Amendments

Amended layout of buildings/outside areas
	Additional background information
\checkmark	Amended design - marry window details - sizes
	Revised access arrangements
	Change of description of proposed development
	Change in site boundaries
	Other (as specified below)

PROPOSED EXTENSION at CRAGWELL COTTAGE, AISLABY, YO21 1SZ. Your ref: NYM/2012/0730/FL.

Window openings:

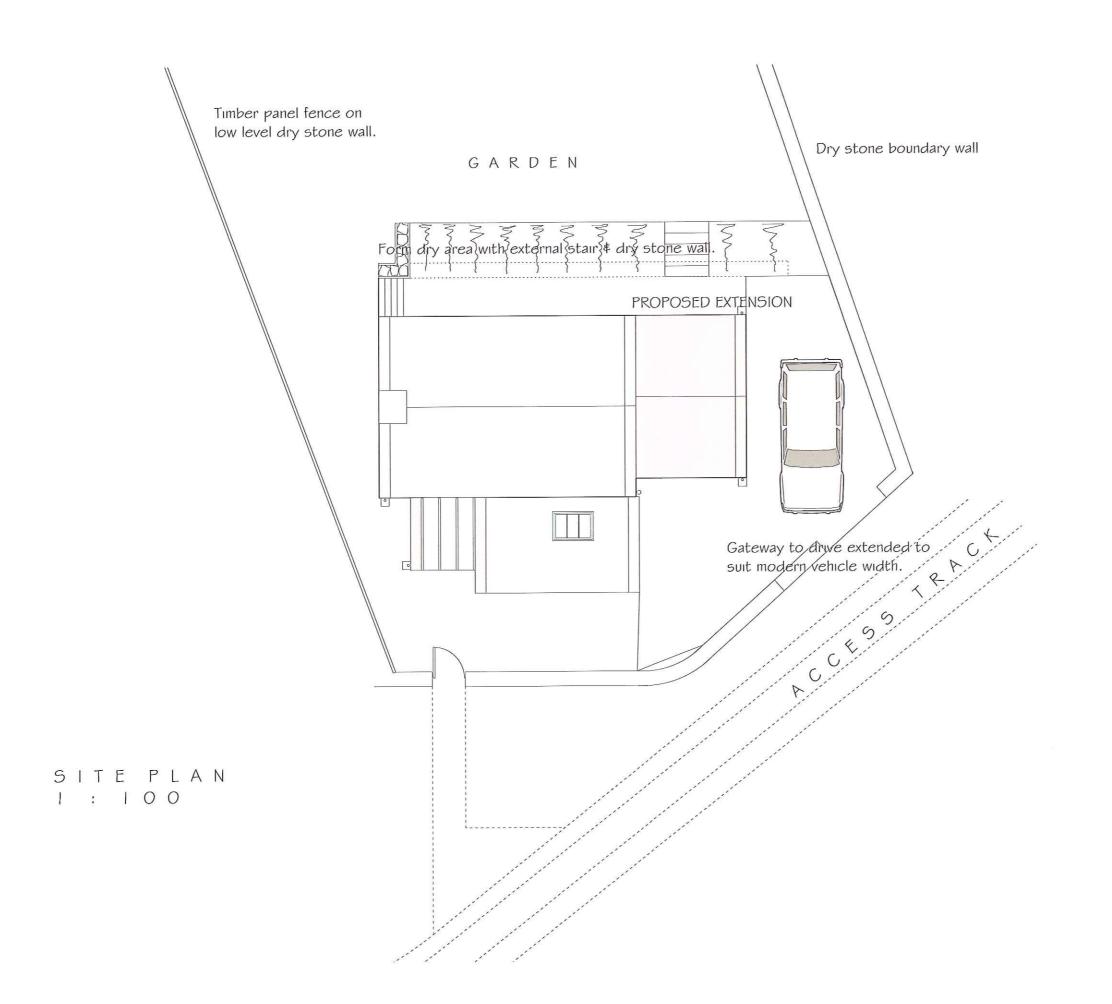
- Shower Room.
 - This has been altered to a four pane arrangement as your proposal.
- Ground Floor windows to the extension.
 - In the proposed extension it was intended that some elements of the existing bay window building would remain such as the amount of daylight and the view across the valley and this is the reason for the window design.
 - However, in response to your suggestions, I have reduced the width of the front window from 1.20m to 1.04m and the height from 1.50m to 1.40m. This still provides a view out across the valley and facing due south admits direct sunlight.
- The window to the side elevation has also been reduced in width as the front frame but also in height from 1.50m to 1.20m.
- The gable window at First Floor level altered as your suggestion and similar size to that existing. (Amended survey drawing also attached).

- Rear elevation
 Staircase window frame reduced in height.
 Other rear elevation windows; upper floor is existing opening.
 Ground Floor window to sitting room. The window opening has been altered to a more traditional style and marginally larger as a check on the floor area to glazing ratio showed some shortfall.
- The rooflight to the front elevation has been noted to be conservation style.
- It is intended that the Porch roof will be double glazed units as opposed to polycarbonate.

Drawing: PROPOSED SITE PLAN SCHEME A

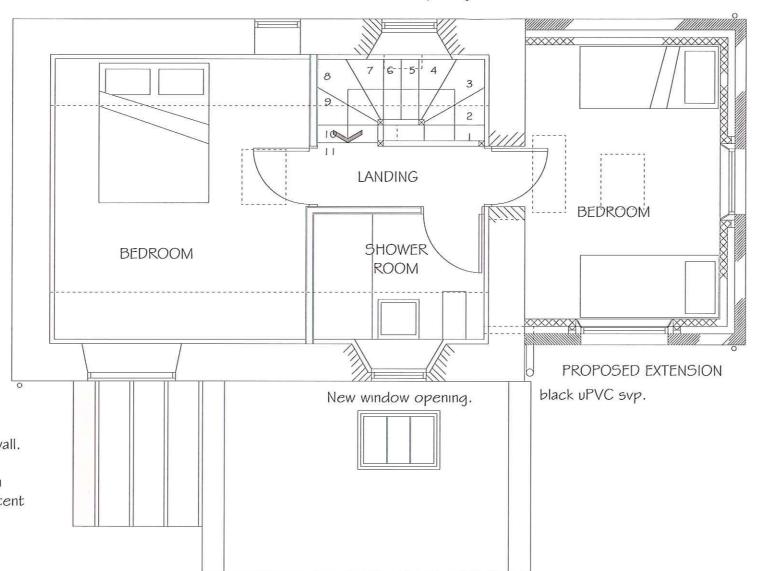
REVISION A Roof light altered to conservation type.

Roof window altered to conservation type. Bathroom window narrowed in width. Extension: Bedroom window narrowed width.
